Our Ref: 23-04/001256
DSC Ref: CA 2023_5309/1
Date: 29 June 2023

RE: RESPONSE TO INFORMATION REQUEST IN RELATION TO AN APPLICATION FOR MATERIAL CHANGE OF USE FOR TWO (2) DUAL OCCUPANCIES AND SHORT-TERM ACCOMMODATION AND RECONFIGURATION OF A LOT (2 LOTS INTO 4 LOTS)

SITE / RECONFIGURATION PLAN
1:200

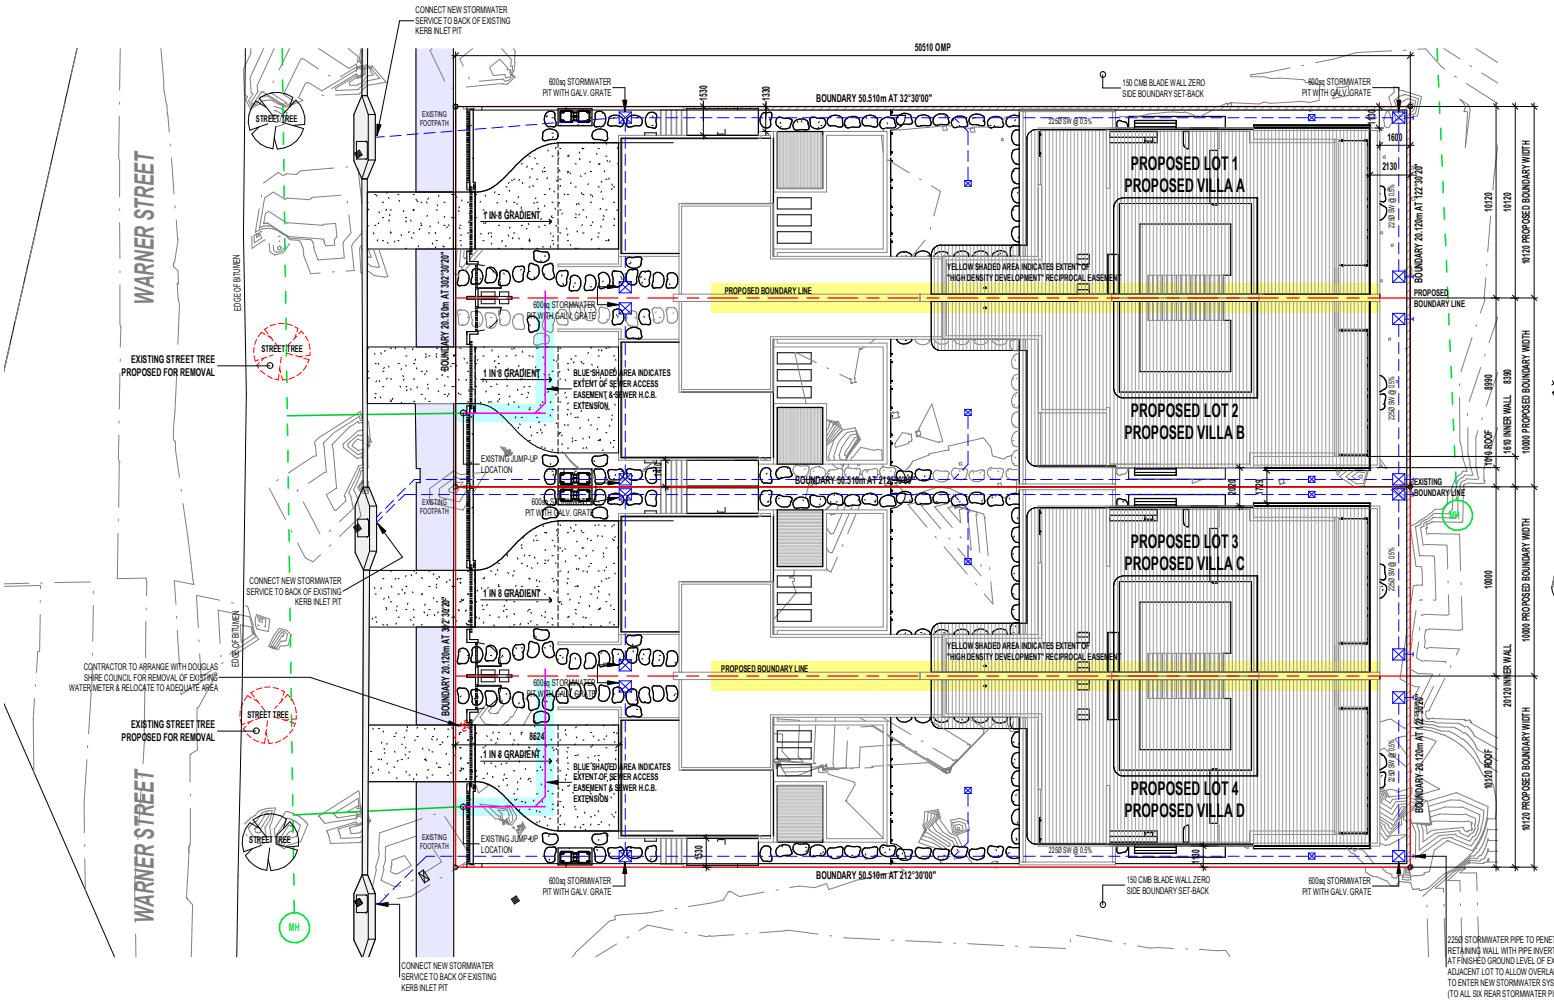
It is noted that the Civil Work and lot layout plan still refer to the original application.

3. Please provide a proposed plan of civil work, material colours and finished and landscaping that demonstrates the development meets the code requirements.

In terms of civil works, the updated Site Plan illustrates proposed sewer and stormwater infrastructure. It is submitted that earthworks and retaining wall design will form part of the Building Approval documentation and that Council may want to impose a condition requiring endorsement of such plans prior to obtaining Building Approval.

VANTAGE POINT SECTION
1:100

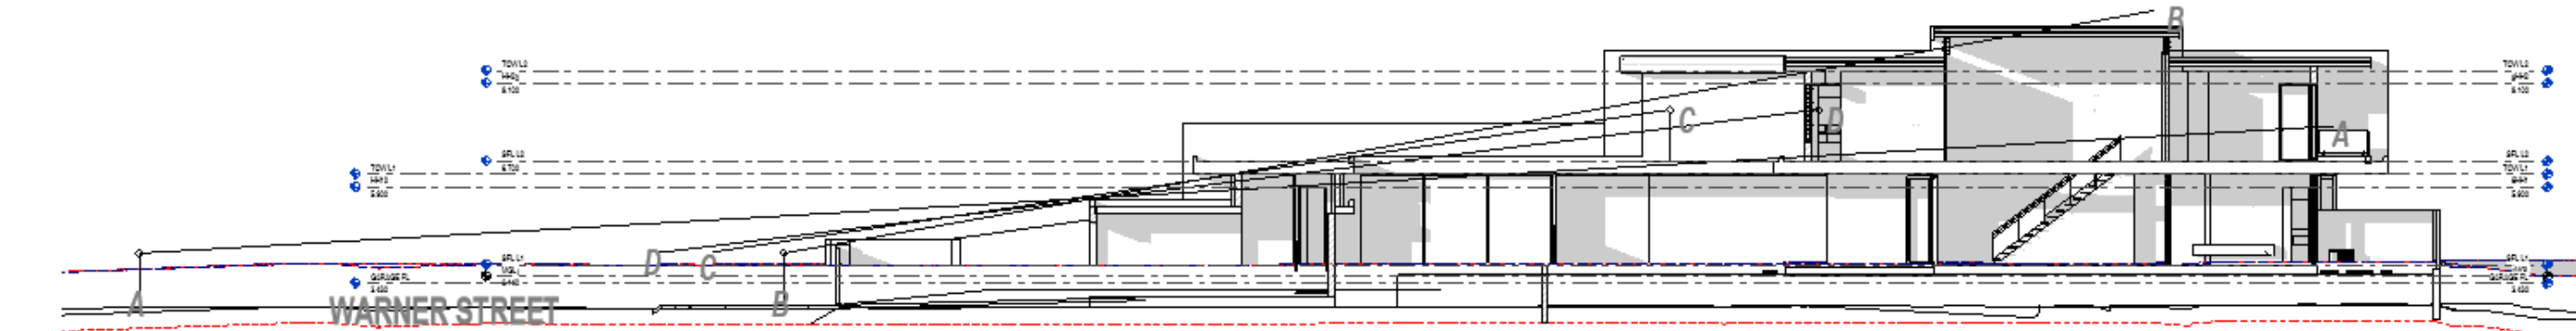
The current amended proposed development of setting the buildings well back from the street with garages in front is not considered appropriate given the Centre Zoning and the desire for development to address the street.

1. Please provide advice to the consideration of the above comments to meet the code requirements.

The changes have involved the lowering of the garages to reduce their visual prominence and allow more visibility to the main buildings behind which remain elevated, and an increase to the façade treatment of the pedestrian entries to increase their visual prominence. Overall, the revised proposal is considered to better address the street and provide increased casual surveillance. In addition to the Perspectives which illustrate this, a Vantage Point Section is provided which shows the view lines towards the building from various points in the Warner Street road reserve, demonstrating that much of the second level of the main building is visible from the road reserve and footpath in front of the site. This is aided by the sloping nature of the site which places the ground level of the main buildings 1.1m higher than the now-lowered garages.
